# Staff Presentation to the **Portland Design Commission**

**Land Use Review Hearing**  
**LU 15-259840 DZM**  
**BURNSIDE DELTA**

February 4, 2016

## ARCADE

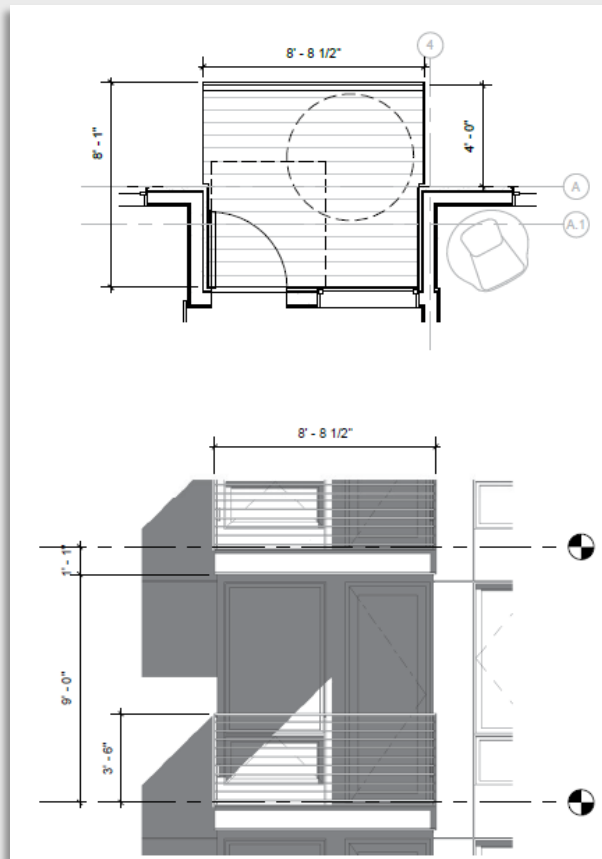
*The proposal includes canopies and balconies instead of an arcade or similar encroachment (Sheet C11).*

**?:** *What form of expression meets Guideline A5-1:*

*"Maintain, continue and reinforce the effect of sidewalk arcaded buildings fronting on East Burnside Street."*

### Proposed Condition

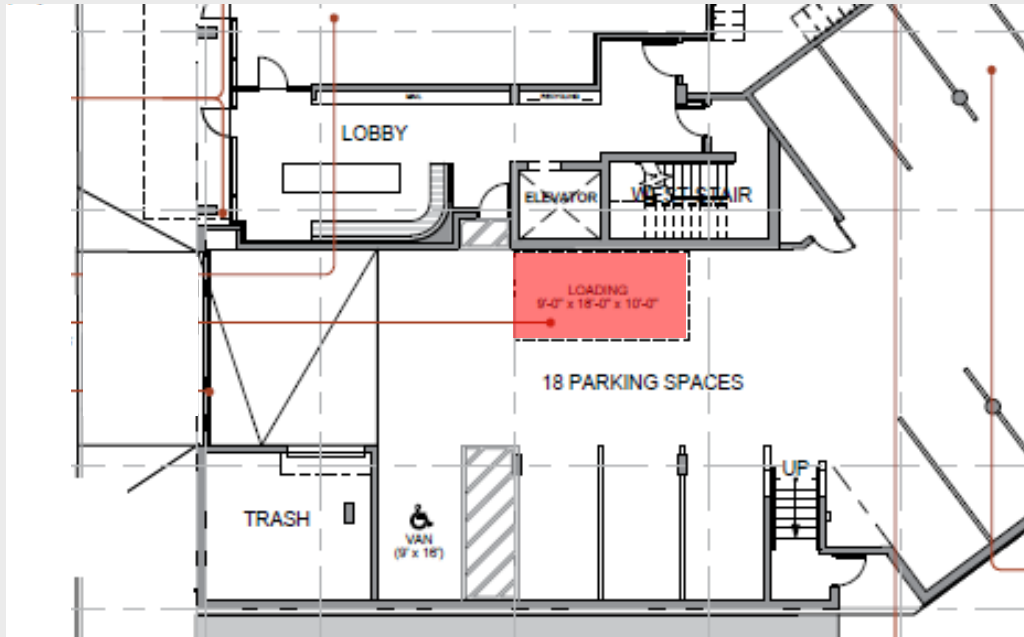
*Parking areas shall be designed so that a vehicle may enter or exit without having to move another vehicle. PBOT has indicated that prior to supporting this Modification, a Queuing Analysis shall be submitted. At the time of the publication of this Staff Report, no such analysis had been submitted. As such, Staff cannot determine that the parking layout as proposed will better meet Guideline C1-1.*
